GEXL80 CORRELATION FOR SVEA96+ FUEL

NEDO-33107-A

SAFETY EVALUATION BY THE OFFICE OF NUCLEAR REACTOR REGULATION

LICENSING TOPICAL REPORT NEDC-33107P, "GEXL80 CORRELATION

Figure 2-1. SVEA96+ Assembly Rod Numbering System

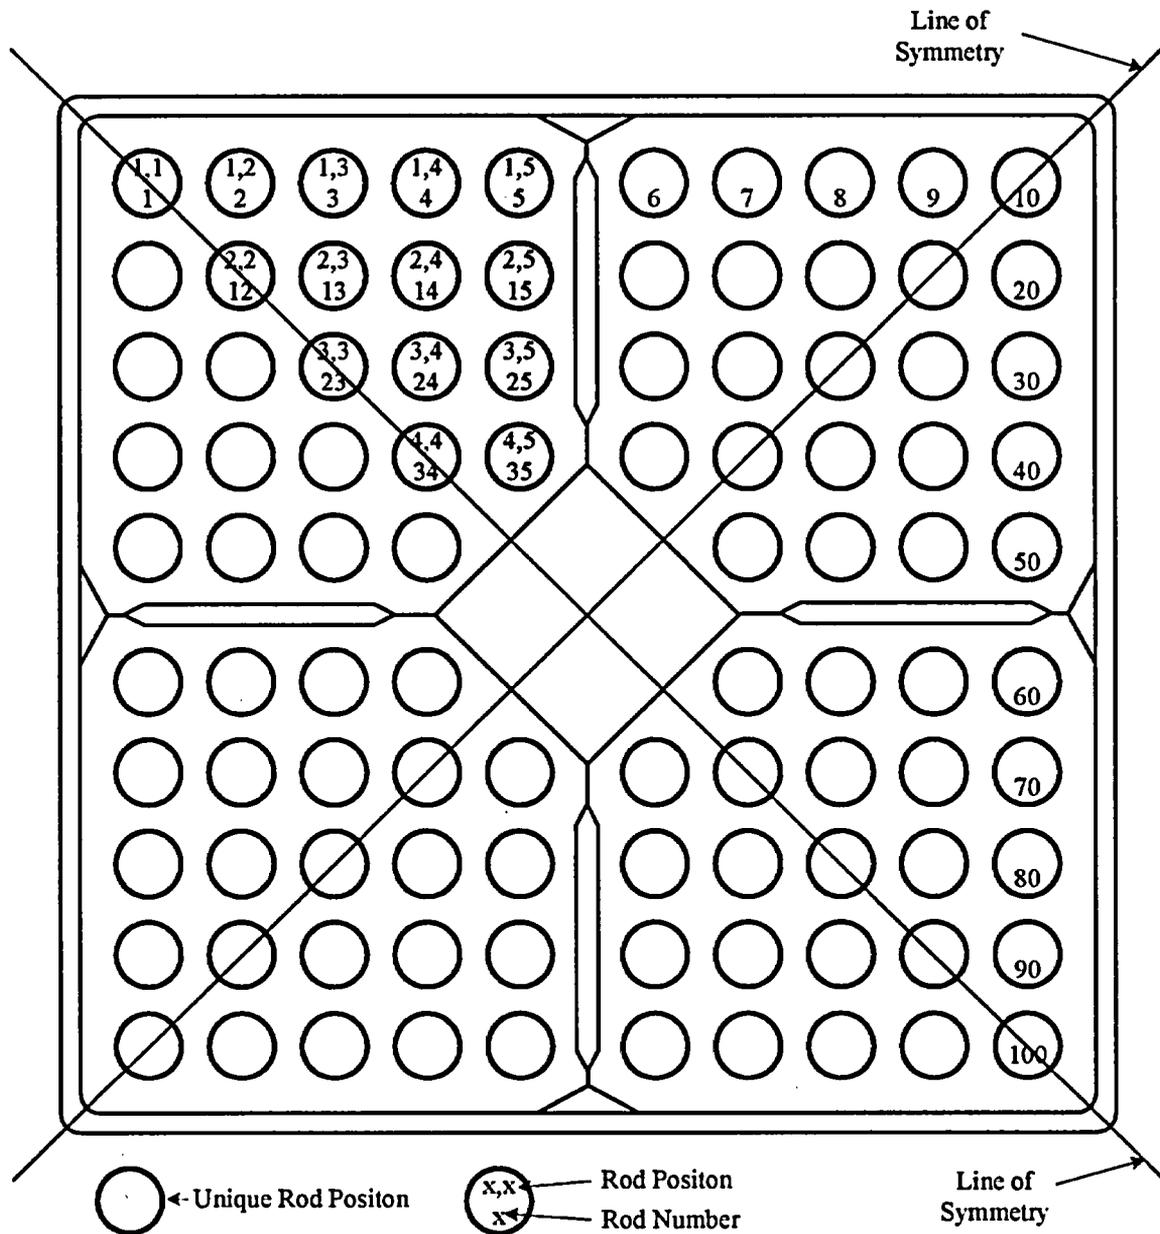
The SVEA96+ bundle is divided into four mini-bundles by the water cross as shown in Figure 2-1. The four mini-bundles are four parallel flow channels that all are subject to the same pressure drop. If the SVEA96+ bundle has a quadrant symmetric pin power distribution, the four mini-bundles have the same power and they will also have the same mass flux and critical power performance. If, on the other hand, the pin power distribution is not symmetric the four mini-bundles will have different powers. The mini-bundle with the highest power will have the highest vapor generation and, therefore, its two-phase pressure drop will increase relative to the other three mini-bundles. Since the four mini-bundles all have the same pressure drop, the impact of the higher two-phase pressure drop in the hottest bundle must be offset by a reduced inlet flow and a corresponding lower single phase pressure drop. Similarly the mini-bundle with the lowest power will have less vapor generation, less two-phase pressure drop and correspondingly must have a higher inlet flow and higher single phase pressure drop. Therefore the impact of a power mis-match between the four mini-bundles in the SVEA96+ fuel bundle is that the mini-bundle with the highest power has a mass flux that is less than the average for the bundle, and the mini-bundle with the lowest power has a mass flux that is higher than the average. For a mini-bundle a reduction in the mass flux will produce a corresponding reduction in the mini-bundle critical power (critical power is a monotonically increasing function with mass flux).
